STAFF REPORT

Department of Metropolitan Development Division of Planning Current Planning Section

Case Number: 2023-ZON-082
Address: 1102 and 1138 Roosevelt Avenue (Approximate Addresses)
Location: Center Township, Council District #17
Petitioner: Roosevelt Landsite, LLC, by Russell L. Brown
Request: Rezoning of 6.60 acres from the I-4 district to the C-S district to provide for a mixed-use development including multi-family dwellings, neighborhood retail uses and a parking garage.

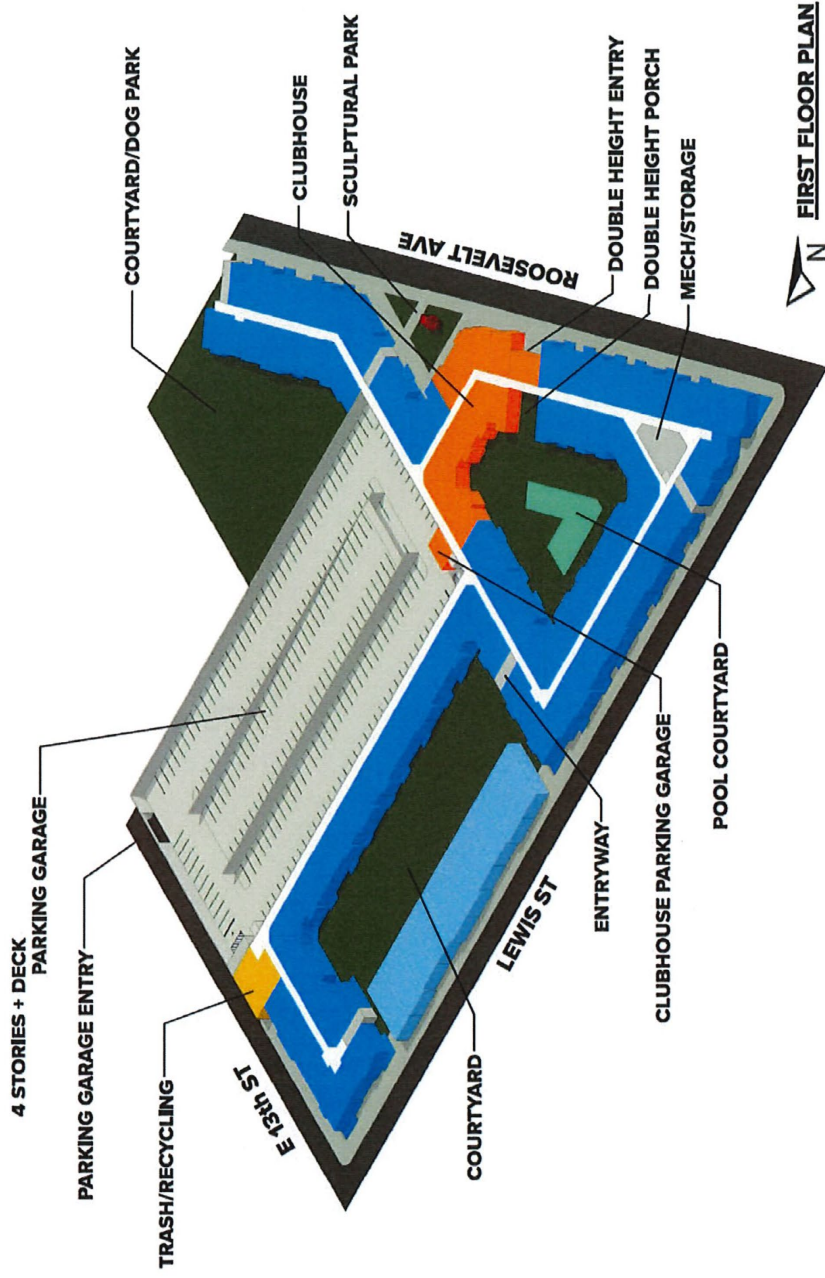
- ◇ Staff, however, is concerned with the amount of parking and the lack of detail regarding the proposed shared parking arrangement. Based on conceptual documents and the required parking, in accordance with the Ordinance, a minimum for 271 parking spaces would be appropriate for this proposed development. The remaining 329 parking spaces seems excessive without more information and details.

- ◇ Staff is also concerned with the architectural character of the parking garage because of proposed mass of the structure and visibility from the Interstate 70. Additionally, no information or details have been provided regarding the design of the parking garage and the proposed exterior materials. Staff believes that masonry should be considered as the primary exterior material, but the City Architect would have final approval of the elevations, including exterior materials.

- ◇ The conceptual site plan and elevations would require Administrator Approval of final documents. Additionally, a final landscape plan that would include the Green Factor and a photometric plan would need to be submitted for Administrator Approval.
